Darlington New Nuclear Project

**Northwatch Comment on the
Application by
Ontario Power Generation for the
Renewal of the
Nuclear Power Reactor Site
Preparation Licence for the
Darlington New Nuclear Project**

Ref. 2021-H-04

May 3, 2021

Figure 4: Location of Darlington Nuclear Site

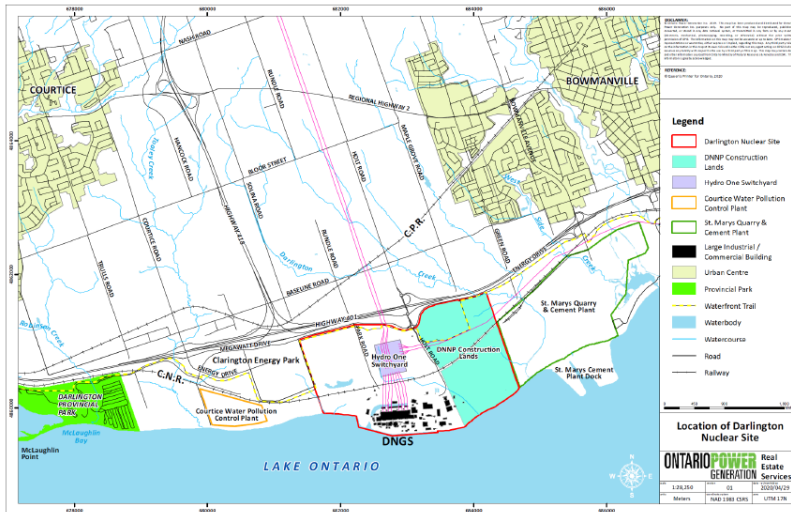
However, the several diagrams included in the OPG application fail to depict the radioactive waste management structures and facilities associated with this project:

REQUEST: the Commission direct OPG that, should they decide to return in 2022 they do so only with a complete application, that application should include details on site configuration that accommodates waste storage and reflects reactor selection

Figure 9: OPG Darlington New Nuclear Project (DNNP) Proposed Site Layout

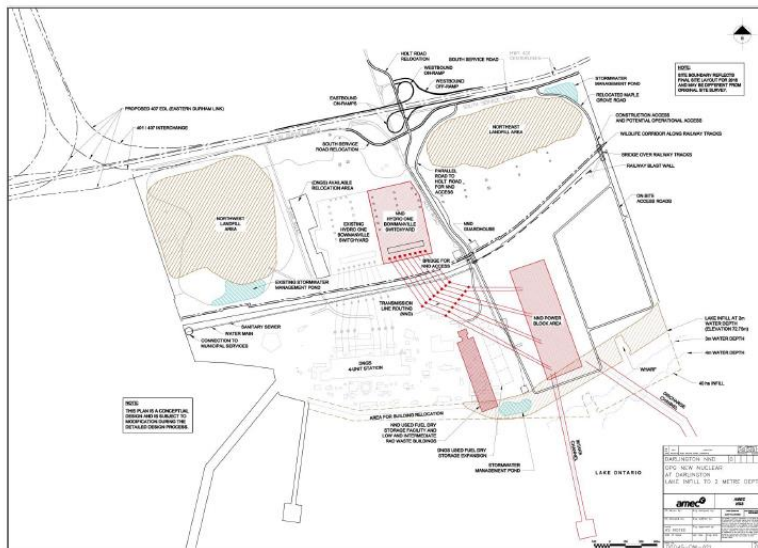
These requirements do not appear to be met in full. For example, figure 9³² simply shows a rectangle labelled ‘*power block area*’, but does not attempt to illustrate any of the actual structures within this power block area.

Northwatch notes that Figure 9⁴⁰ actually shows an area of lake infill as well as the NND power block area extending beyond the current shoreline by means this infilled area, suggesting that infill will be required.
